Technical Information

911 GT3 Cup (991)

Valve insert

Radventil / Wheel valve

Bild 1

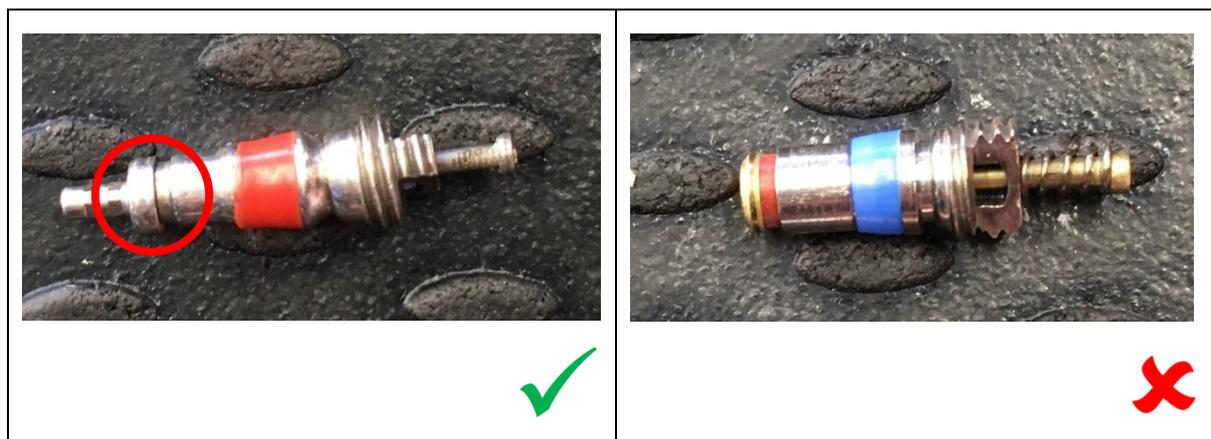
Porsche Motorsport weist darauf hin, dass beim nächsten Betrieb des o.g. Fahrzeuges die Ventileinsätze der Radventile (9F0.601.361) durch die in der Regel rot oder schwarz markierten Ventileinsätze (9F2.601.221) zu ersetzen sind. Es müssen Ventileinsätze verbaut werden, die der im Bild 1 gezeigten Ausführung entsprechen und über eine Abdeckkappe (roter Kreis) die Ventilführung fixieren. Die Ventileinsätze sind bei jedem Michelin Renndienst erhältlich oder alternativ Porsche Teilenummer 9F2.601.221. Bei Benutzung der blauen Ventileinsätze (Bild 2) ohne Ventilkappe kann es im Renneinsatz zum Druckverlust kommen. Diese sollten nicht mehr verwendet werden. Um zusätzlich einen Verlust des Reifendrucks zu vermeiden, sind bei jedem Fahrzeugbetrieb immer Radventilkappen mit Gummidichtung zu verwenden, z.B. Porsche Teilenummer 9F2.601.259.

Image 1

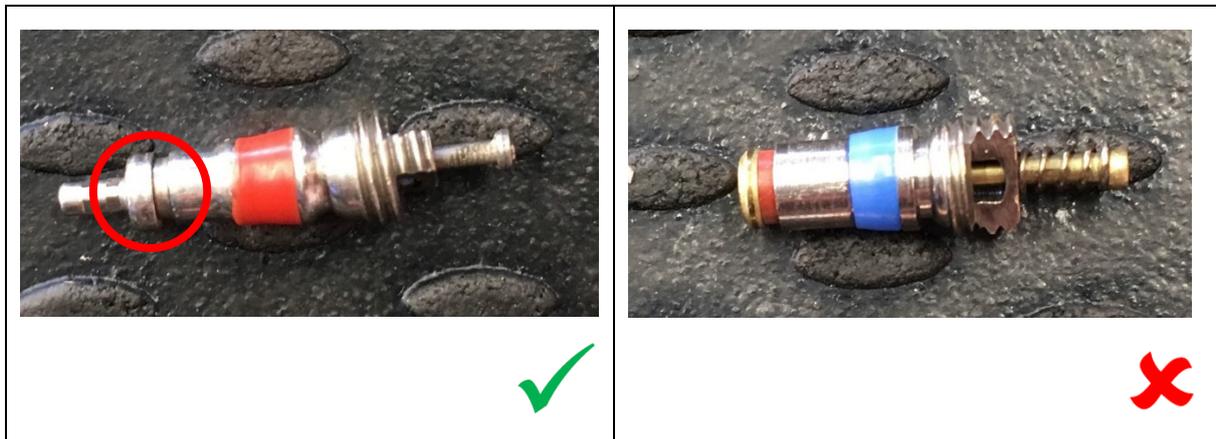
Porsche Motorsport advises, that before the next operation of the aforementioned vehicle, the valve insert of the wheel valve (9F0.601.361) is to be replaced by the typically red or black colored valve inserts (9F2.601.221). Valve inserts of this kind shown in Image 1 which utilize a shroud fixing the valve guide (circled in red), must be used. Such valve inserts are available through regional Michelin race supply partners, or alternatively under the Porsche part number 9F2.601.221. Usage of the valve inserts shown with the blue marking (Image 2) can result in pressure loss, and therefore their usage should be discontinued. To further prevent tyre pressure loss, valve caps with integrated rubber seals are always to be used; for example, those available under Porsche part number 6F2.601.259.
